Florida Department of Transportation

Section 008

SS0050104- Control of the Work.

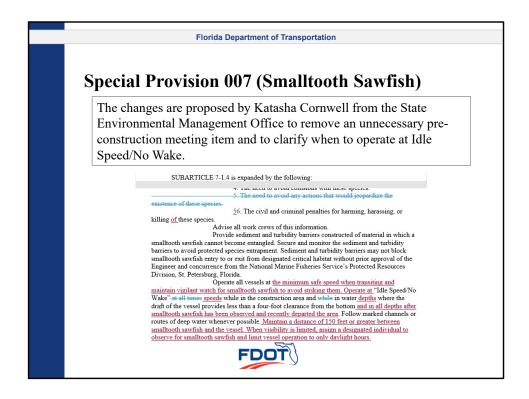
PT systems will be accepted through the shop drawing submittal process instead of through a pre-approved list. Updated Footnote 1 in Table 5-1 to reflect that PT systems will be accepted through the shop drawing submittal process instead of through a pre-approved list.

SP0070104-5 Legal Requirement and Responsibility to the Public – Small tooth Sawfish.

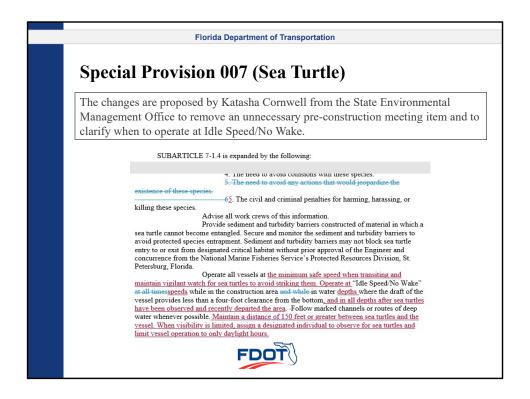
As a result of the agencies updating their requirements. Removed unnecessary preconstruction meeting item and to clarify when to operate at idle speed/ no wake.

SS0071303 – Legal Requirements and Responsibility to the Public – Insurance Required for Construction at Railroads.

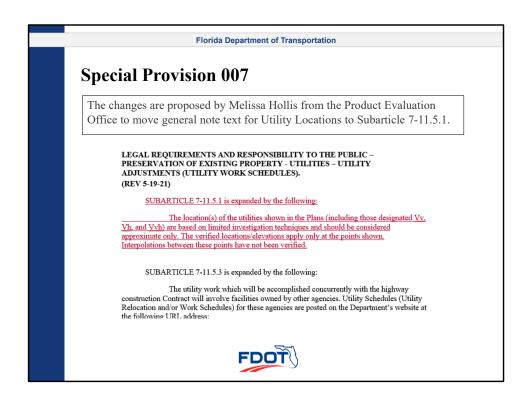
Align submittal of railroad protective liability insurance documents with the expectations of the district/state railroad coordinators. Require railroad protective liability insurance documents be submitted at the preconstruction conference.

SS0080604 - Prosecution and Progress.

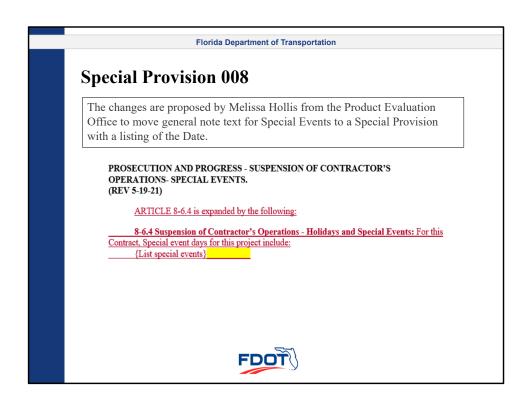
Moved General Note (FDM Chapter 311/914) text for Special Events to specification subarticle 8-6.4, with listing of Date/Event.

SP0080604 (NEW) Prosecution and Progress - Suspension of Contractor's Operations-Special Events.

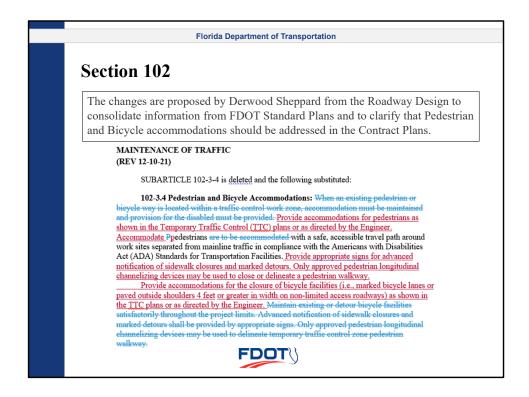
Moved General Note (FDM Chapter 311/914) text for Special Events to specification subarticle 8-6.4, with listing of Date/Event.

SS1020304 - Maintenance of Traffic.

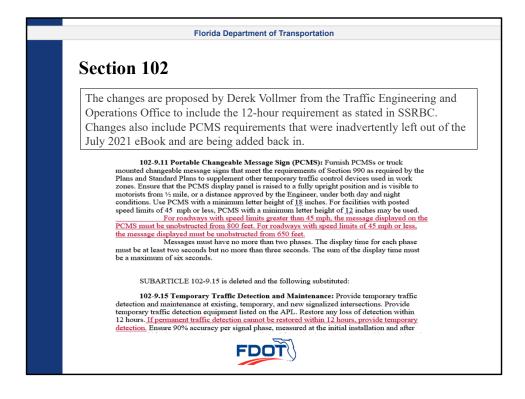
Added clarification that the Ped/Bicycle Accommodations are included in the TTCP and also clarified that paved shoulders 4' or greater in width on non-limited access facilities are considered a "Bicycle Facility".

SS1020912 - Maintenance of Traffic.

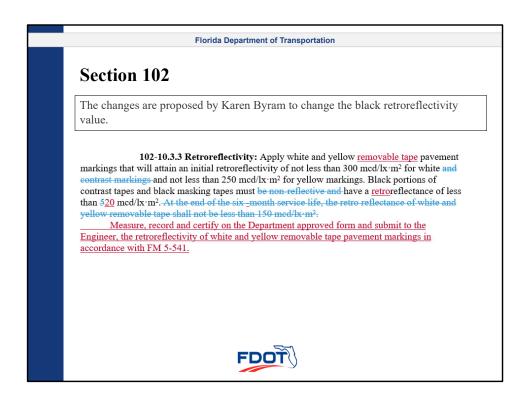
Added "If permanent traffic detection cannot be restored within 12 hours, provide temporary detection.

SS1021000 – Maintenance of Traffic.

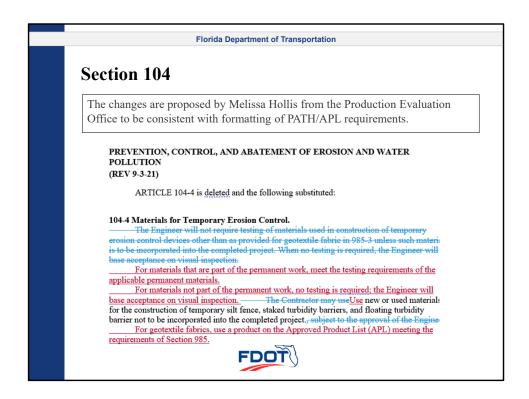
The Retroreflectivity value for black has been changed from 5 to 20 mcd/lx·m2 based on asphalt and concrete retroreflectivity baseline values.

SS1100201 - Clearing and Grubbing.

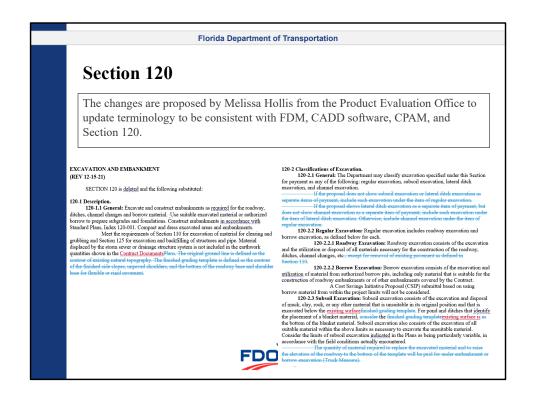
Updated the limits for Clearing and Grubbing.

SS1200100 - Clearing and Grubbing.

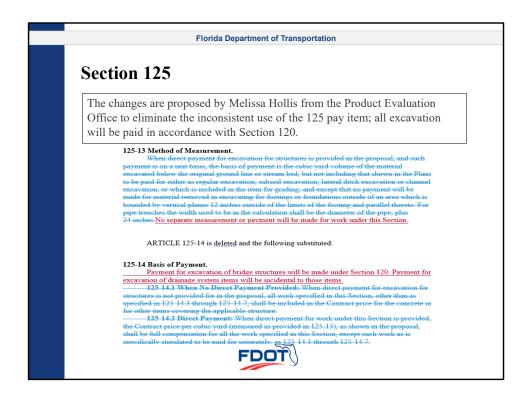
^{*}Updated terminology to be consistent with FDM.

^{*}Updated measurement and payment to use Plan Quantity items.

SS1251300 - Excavation for Structures and Pipe.

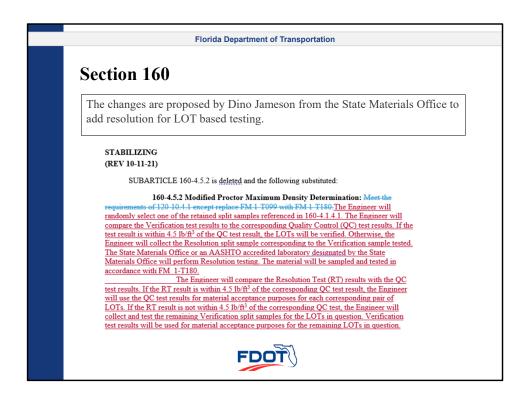
Eliminate the inconsistent use of the 125- pay item; all excavation will be paid in accordance with Section 120.

SS3000303 - Prime And Tack Coats.

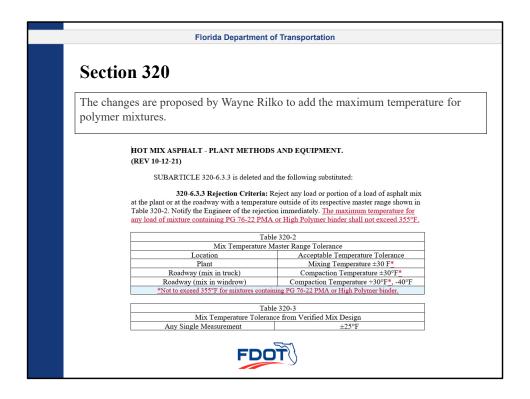
Removed EPR language, added criteria for distributer nozzle openings, and tack application requirements when using a spray paver.

SS3200603 - Hot Mix Asphalt - Plant Methods And Equipment.

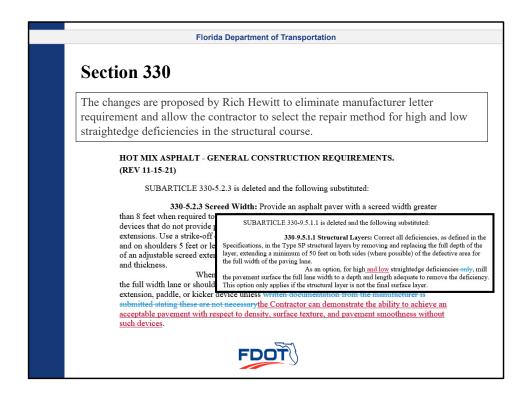
Added the maximum temperature for polymer mixtures.

SS3300502 - Hot Mix Asphalt - General Construction Requirements.

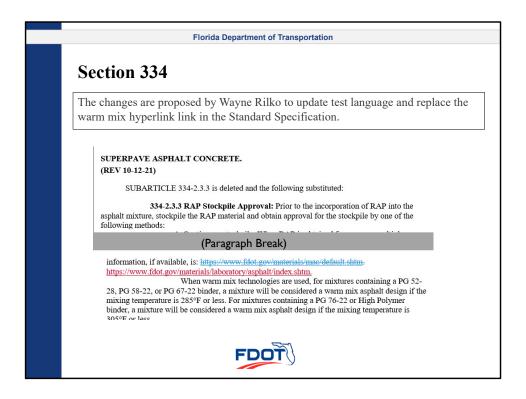
5.2.3-Eliminates manufacturer letter requirement, allows contractor to demonstrate ability to pave with screed extension without augers, paddles, etc. 9.5.1.1-Allows contractor to select repair method for low and high straightedge deficiencies in the structural course.

SS3370201 - Asphalt Concrete Friction Courses.

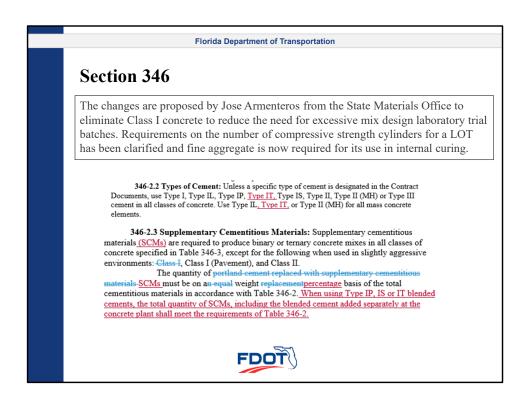
- 1.Update website for warm mix technologies.
- 2. Show FC-5 binder content in Table 337-2.
- 3. Requirements for the FC-5 fiber supply system.
- 4. Requirements for the FC-5 hydrated lime supply system.
- 5. Small Quantity Pay Table Pay Factor up to 1.05.

SS3460200 – Structural Portland Cement Concrete.

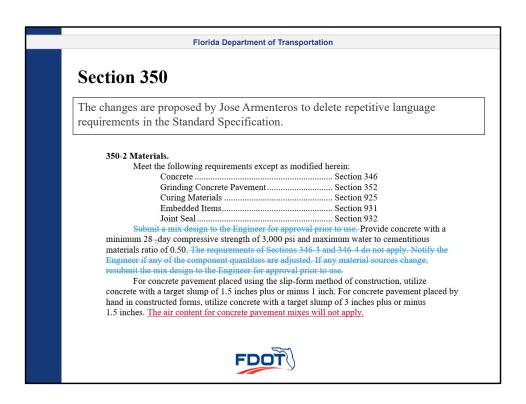
The statistical analysis of the concrete compressive strength production test data indicates that the strengths of the Class I mixes meet the strength requirements of Class II concrete. Therefore, there is need for the elimination of Class I concrete. The upgrading of Class I to Class II will reduce the need for excessive mix design laboratory trial batches. Table 346-1 excludes Type IT Cement, which should be added. The LOT size definition of Class I pavement in Section 346 is repeat of the definition in Section 350. In Section 346 only reference should be given to Section 350 regarding LOT size definition, reduced frequency for acceptance testing, and other requirements of Class I pavement described in Table 346-3. The requirements of the number of compressive strength cylinders for a LOT has to be clarified, whether it is only based the average compressive strengths of three cylinders or average compressive strengths of two cylinders. A subarticle on lightweight fine aggregate was required for its use in internal curing. Implementation of three research projects related to internal curing: BDV31-977-47, BDV31-977-86 and BDV31-977-114. Article 346-3 and other related articles and sub-articles of Section 346 are modified by replacement of Class I concrete with Class II concrete. Type IT Cement has been added to the list of types of cement in Table 346-1. The LOT size definition of Class I pavement in Section 346 has referenced

Section 350 in lieu of repeating the requirements of Section 350. Additionally, Section 350 has been referenced regarding the LOT size definition, reduced frequency for acceptance testing, and other requirements of Class I pavement, described in Table 346-3. The requirements of the number of compressive strength cylinders for a LOT has been clarified, which is based on the average compressive strengths of at least two test cylinders. Addition of Subarticle 346-2.5 Lightweight Fine Aggregate (LWFA) for Internal Curing.

SS3530303 - Concrete Pavement Slab Replacement.

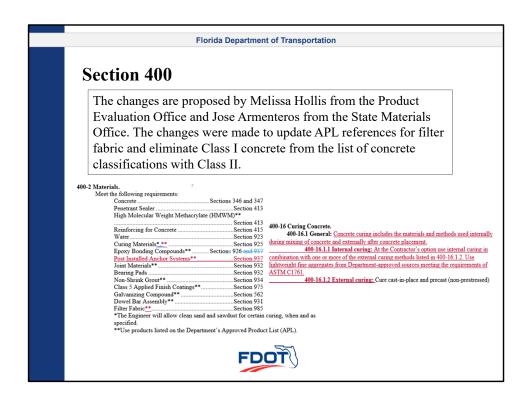
Specifies demonstration slabs are to be located "at the project site".

SS4000200 – Concrete Structures.

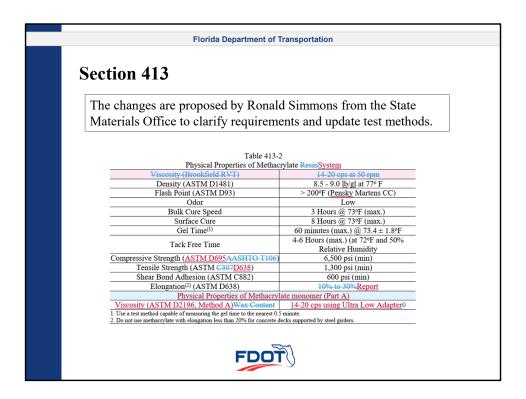
The proposed Section 346 will eliminate Class I concrete from the list of concrete classes. Accordingly, there is need to delete Class I Concrete from the entire specifications, including Sub-article 400-23.9 Payment Items.

SS4130302 - Sealing Cracks and Concrete Structure Surfaces.

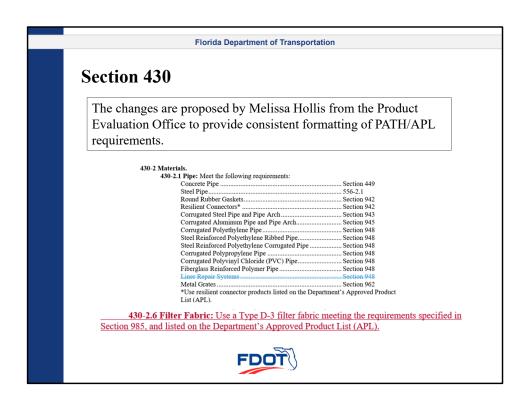
Existing language needed to be changed to clarify requirements and update test methods. Adjusted language to make clear it is a system, replaced 2 test methods, clarified an additional method, and increased the initial rate of dispersion based on field comments that it was too low.

SS4500203 Precast Prestressed Concrete Construction.

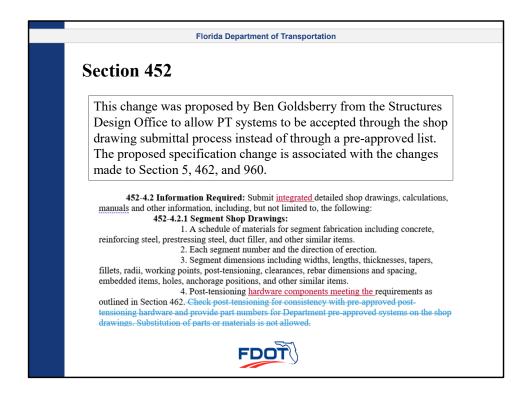
2.3: Adjust monthly camber measurement requirement beyond 120 days. 5: Strengthen language regarding supplemental reinforcement. 10.7.1: Include requirement to follow CFRP strand manufacturer's instructions. 12.2: Remove "pre-approved" repair language.

SS4520402 Precast Segmental Bridge Construction.

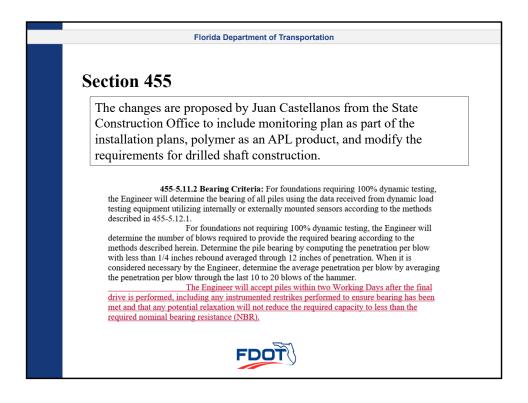
Revisions to accept PT systems through the shop drawing submittal process instead of through a pre-approved list.

SS4550511 – Structures Foundations.

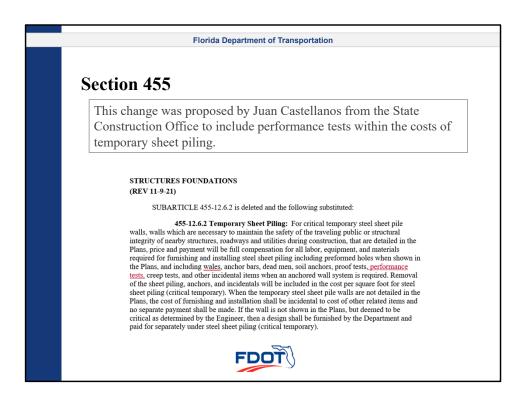
To address a request from FTBA to indicate a timeline for FDOT pile acceptance, to include a monitoring plan as part of the Installation Plans, to include the polymer as an APL product and to address a request from LESS contractors to give them some flexibility in the requirements of drilled shaft construction.

455-5.11.2: Add a paragraph indicating FDOT pile acceptance time. 455-10.1: Add an item requesting a vibration and settlement monitoring plan. 455-14.3: Sub-article added as part of the introduction of polymer slurry in the APL. 455-15.1.2: Revised language in one item as part of the introduction of polymer slurry in the APL. Added an item to require a monitoring plan in the Installation Plan. 455-18.1 Change language to allow LESS contractors to introduce polymer slurry in the casing under certain conditions. Change language to allow LESS contractors to test up to every 12 hours under certain conditions. 455-15.8.3: Change language as part of the introduction of polymer slurry into the APL. 455-15.8.4: Added table to specify polymer properties at the time of concreting. 455-16.3 Changed language to allow flexibility to LESS contractors in the centralizing methods when two different casing sizes are used. 455-47: Added an item to require a settlement monitoring plan in the ACP installation plan.

SS4551206 Structures Foundations.

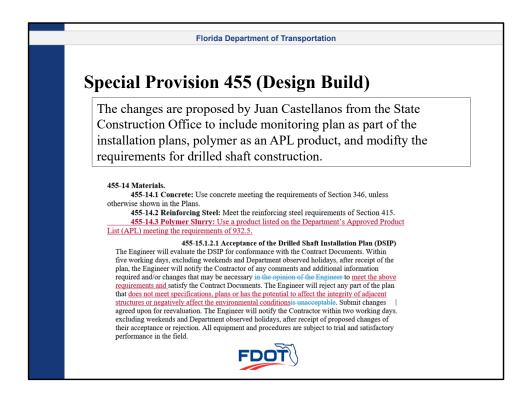
To add language to include performance tests within the costs of temporary sheet piling. Add "performance tests" to the items that must be included within the cost of temporary sheet piling. Changes apply to Conventional Projects that use the Standard Specification SS455.

SS5200100 - Concrete Gutter, Curb Elements, and Traffic Separator.

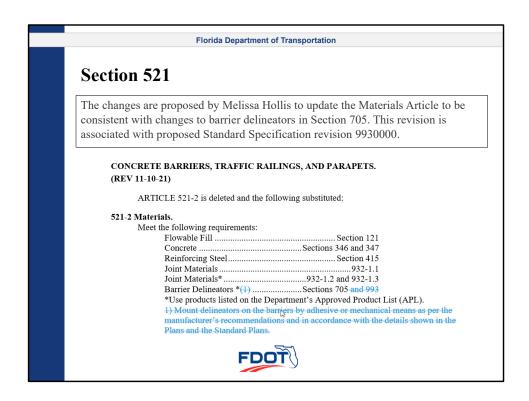
Establish elevation tolerance for curb and gutter to ensure surface paved between curb and gutter meets cross slope and longitudinal profile (elevations) in the plans. Added 1/2" elevation tolerance for curb and gutter.

641-5 Pole Removal.

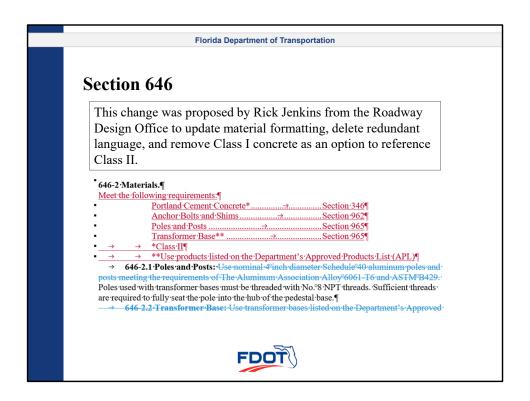
When shallow pole removal removal of the pole and partial foundation removal is specified in the Plans, the remaining pole, foundation and any protrusions, such as pole keys, dead men, guying apparatus, conduit, anchor bolts, or reinforcing steel, must be removed to a minimum depth of 4 feet below existing grade.

When deep pole removal removal of the pole and complete foundation removal is specified in the Plans completely remove each pole including the foundation and all accessories and attachments, such as pole keys, dead men, guying apparatus, conduit, anchor bolts, and reinforcing steel.

SS6540000 – Midblock Crosswalk Enhancement Assemblies.

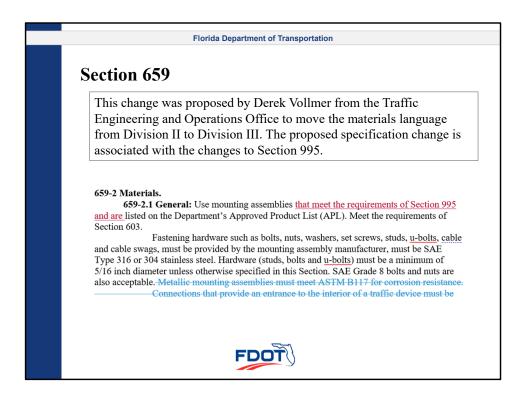
Per the traffic engineering manual, in-roadway light assemblies need to operate in unison with the highlighted signs or beacons.

Added to 654-3, "If installed with highlighted signs or flashing yellow beacons, inroadway light assemblies shall operate in unison and with an identical flash rate as the signs or beacons."

SS6770202 – Equipment Shelter.

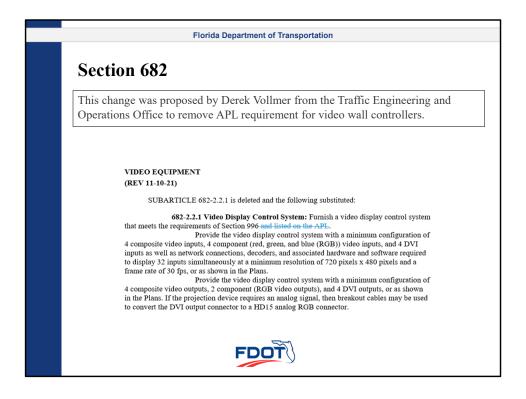
The proposed Section 346 will eliminate Class I concrete from the list of concrete classes. Accordingly, there is need to replace Class I Concrete with Class II concrete in Sub articles 677-2.2 and 677-3.1 Section 677 Specifications.

Replaced Class I with Class II in Sub-articles 677-2.2 and 677-3.1 Section 677 Specifications.

SS7130403 - Permanent Tape Pavement Markings.

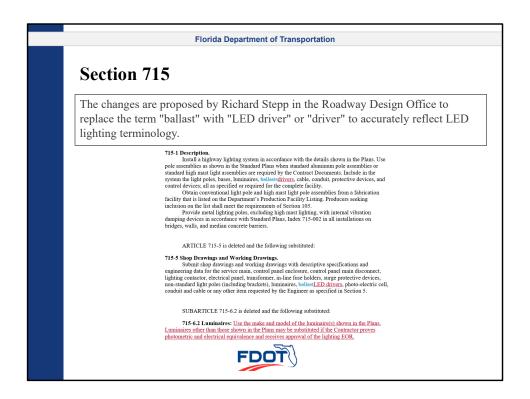
*This proposal is associated with SS9710000 in Division III.
The Retroreflectivity value for black has been changed from 5 to 20 mcd/lx·m2 (millicandelas per square meter per lux) based on asphalt and concrete retroreflectivity baseline values.

SS7150100 - Highway Lighting System.

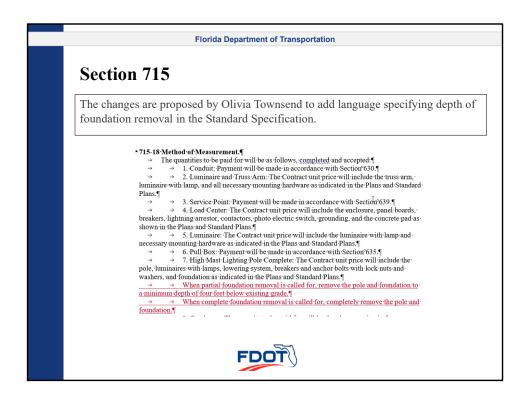
For LED lighting technology, an electrical "driver" is used instead of a "ballast". Next, FDM 231 will require the make and model of LED luminaires to be placed in the Plans. Contractors must use this luminaire unless they receive EOR approval to substitute an equivalent model.

SS9230301 - Water for Concrete.

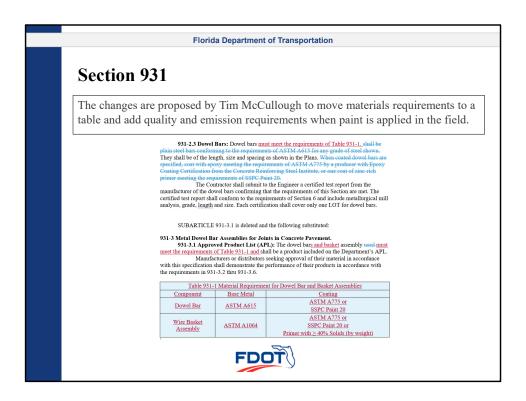
Replaced the ASTM D512 test method with SM 4500 CL B and SM 4110 B in Tables 923-1 and 923-2.

SS9600100 - Post Tensioning Systems.

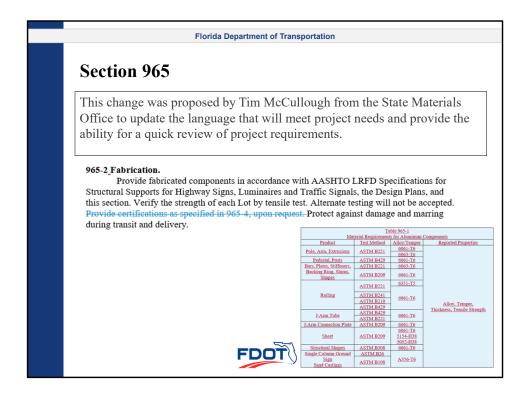
PT systems will be accepted through the shop drawing submittal process instead of through a pre-approved list. Revisions to accept PT systems through the shop drawing submittal process instead of through a pre-approved list.

SS9710000 - Pavement Marking Materials.

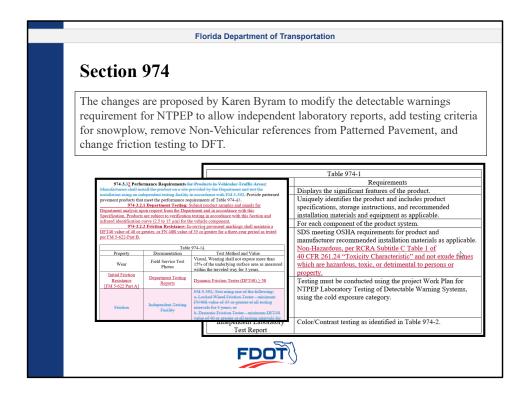
The Skid Resistance test has been changed from BPN to DFT to better reflect the pavement values and ease of testing. The Retroreflectivity value for black has been changed from 5 to 20 mcd/lx·m2 (millicandelas per square meter per lux) based on asphalt and concrete retroreflectivity baseline values. Friction requirements have been applied to all preform materials and the retroreflectivity value has been lowered from 300 to 200 mcd/lx·m2 to accommodate the increased friction and the DFT 40 method. It has been determined that permanent tape is not used for bicycle markings or pedestrian crosswalks, so friction testing is not needed. The name of High Friction Thermoplastic may be confused with preform thermoplastic that has friction elements, so the name needs to be change to include Hot Applied.

SS9920205 – Highway Lighting Materials.

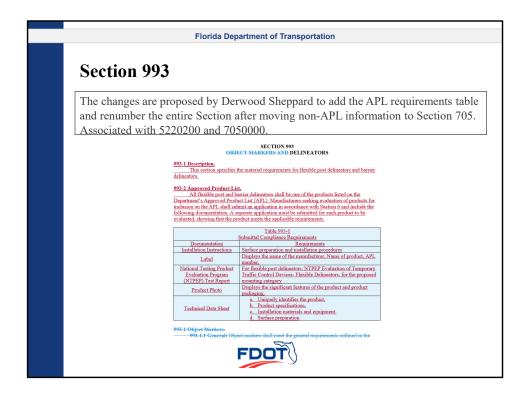
- 1. Electrical engineers called for clarification of Luminaire Cable ground wire color (green).
- 2. Manufacturers called for more practical/effective fuse holder connection and slug material.
- 992-2.5: Added requirement for ground wire to have green color to match other cables.
- 992-2.6: Changed requirement for fuse holder connector material to include a "copper equivalent"
- 992-2.8.1: Changed requirement for fuse holder blank from "solid copper" to "manufacturer's suggested" material.
